**Mountain Chute G.S. – Transformer Replacements T1 & T2
Notification of Conditional Approval of Connection Proposal
CAA ID Number: 2006-EX281**

ASSESSMENT SUMMARY

Mountain Chute G.S. – Transformer Replacements T1 & T2

CAA ID Number 2006-EX281

Figure 1: Mountain Chute GS- Single Line Diagram

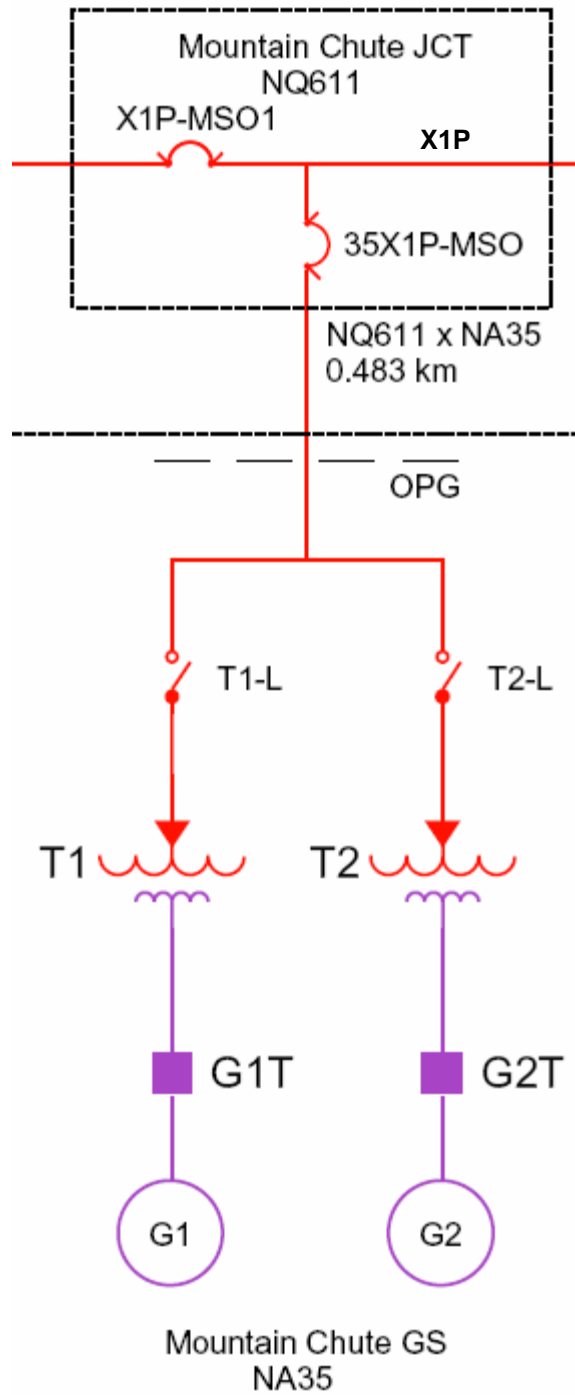
A comparison between the technical specifications of the existing and new replacement transformers is given below. The connection point of the new transformers to the IESO-controlled grid will remain unchanged and is shown in Figure 1.
